RE: Draft Chemical Fate and Transport Modeling Study Report  
San Jacinto River Waste Pits Superfund Site, Harris County, Texas  
Unilateral Administrative Order, CERCLA Docket No. 06-03-10

### Draft Chemical Fate and Transport Modeling Study Report dated February 2012

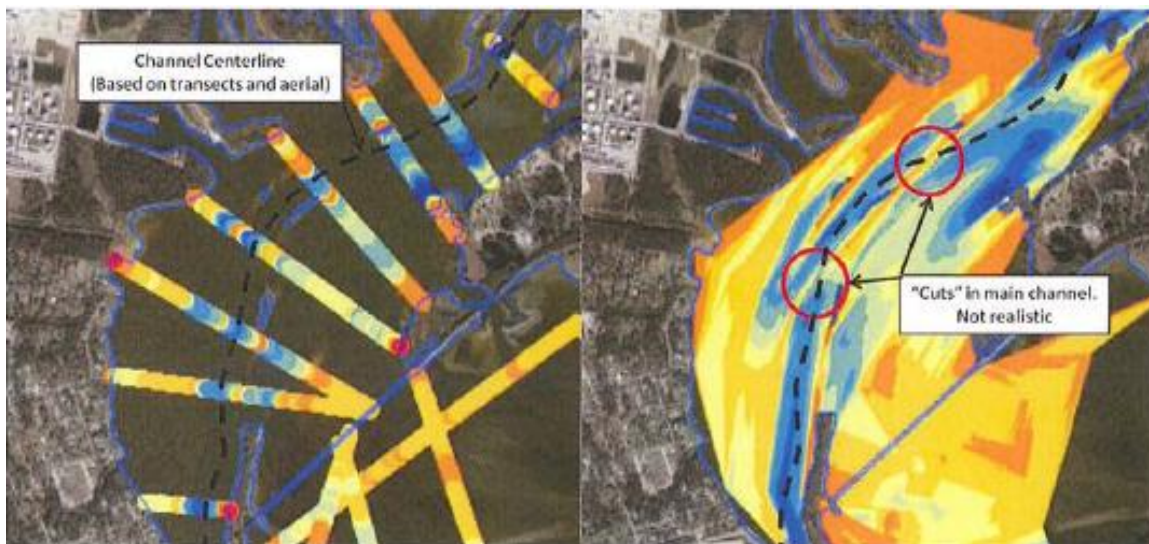
83. **(Appendix A):** With regard to Figure A-3, upstream bathymetric interpolation cuts the main channel twice near Grennel Slough (see figure below). This may affect upstream flow conditions and as such shall be investigated.
